Docket Item # 5 & #6
BAR CASE # 2018-0016 &
2018-0017

BAR Meeting
February 21, 2018

ISSUE: Request for a Permit to Demolish and a Certificate of Appropriateness for alterations and signage.

LOCATION: 115 South Washington Street

Figure 5: 115 S Washington, second submission

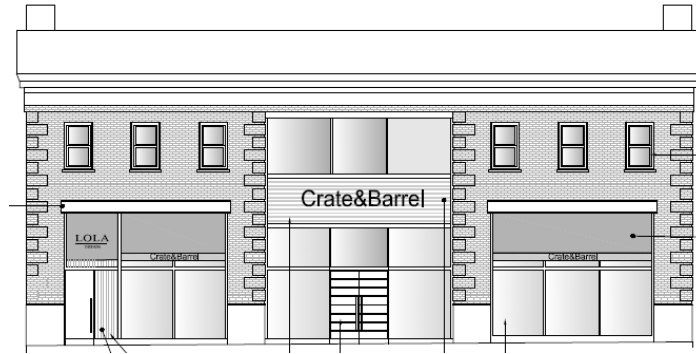
The applicant initially submitted a design that stripped away virtually all of the Colonial Revival design features and substituted modern suburban retail elements (Figure 5) and was quite surprised that staff considered the building at 115 South Washington to have any historic merit. However, once the preservation concerns were explained, they readily embraced a design parti that preserved the columns and Georgian doorway and reduced the signage to a scale that is more in keeping with the GW Parkway. Therefore, the amount of demolition now proposed is limited to the area within and below the three first floor windows on the masonry walls that flank the entrance.

Staff supports the limited amount of demolition presently proposed on the west elevation of 115 South Washington Street, finding that the character-defining elements of this early Parkway building will be retained and the overall proportions of the façade will actually be improved. The existing first floor window sills are quite high above the sidewalk today and the Juliet balconies serve no functional purpose other than to attempt to improve the awkward original proportions of the lower level of this building. (Figure 2) The windows, iron balcony rails and brick wall material being demolished are not of old and unusual or uncommon design, texture and material and could be reproduced easily. Staff, therefore, recommends approval of the Permit to Demolish.

EXHIBIT A-5

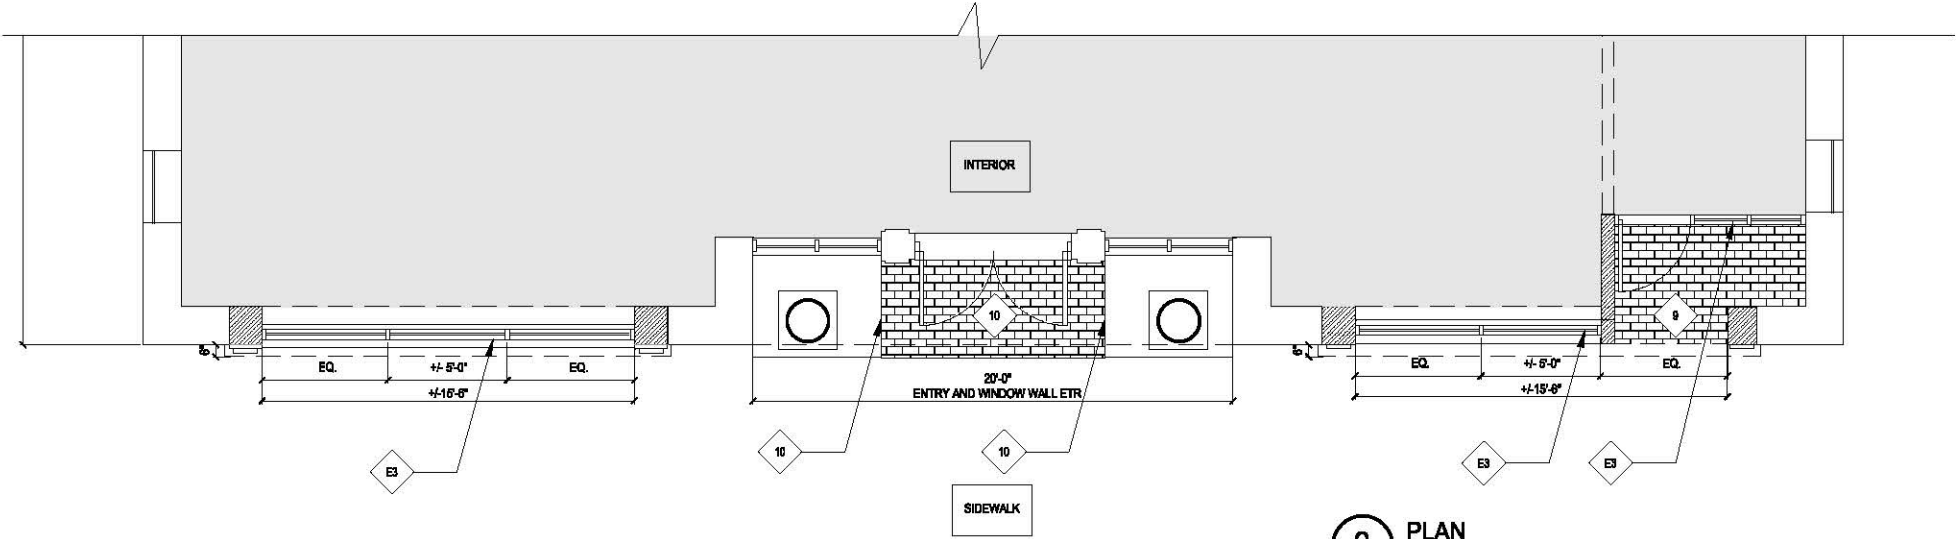
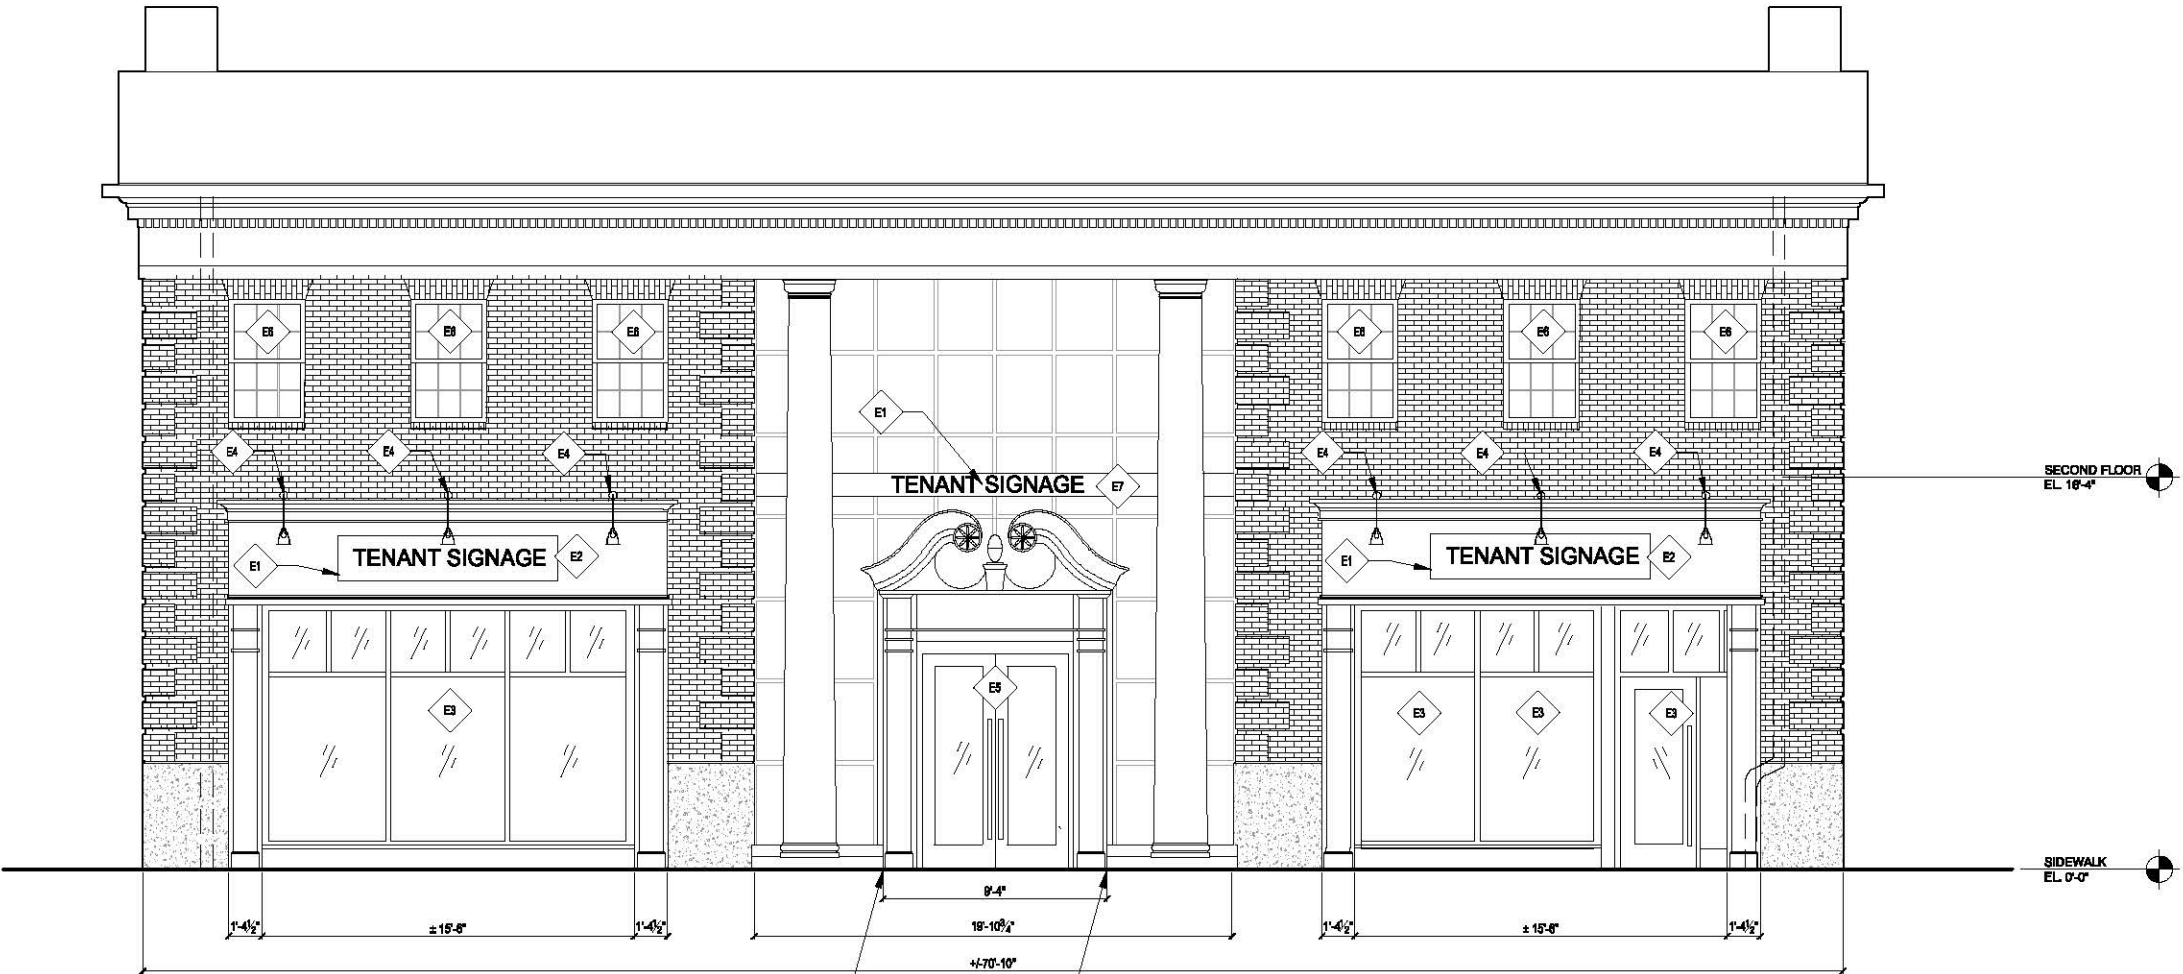
- The park is cognizant of the desire to improve the street level retail for this building, however given the adjacent neighbor of the Washington Street United Methodist Church, and the overall context of Washington Street, there are visual concerns to the proposed work.

- Without a floor plan (existing and proposed), it is difficult understand how the proposed demolition will affect this structure – is the first floor to be split into two retail spaces as there will be two street level entries? Or is the plan to provide for one tenant, if that is the case, reconsider demolishing the front façade and restrict the work to the interior. Reconsider the proposal for three signage if only one tenant is intended. Also, it is unclear what will happen to the basement level when the first floor level is dropped 6'-0" down to street level.

- The proposed storefront windows introduces yet another fenestration design to this façade - consider matching the window proportions of the central entry way. Consider matching the proposed entablature of the storefront windows, with the proportion of the existing building's entablature.

- Reconsider the proposed material: aluminum, as this is a new material being introduced to a building primarily constructed from red bricks, wood windows and concrete.

- Reconsider the removal of the cross finial at the front entry, as this references the former use of this former religious educational facility (Educational Building Washington Street Methodist Church 1953 = corner marker).
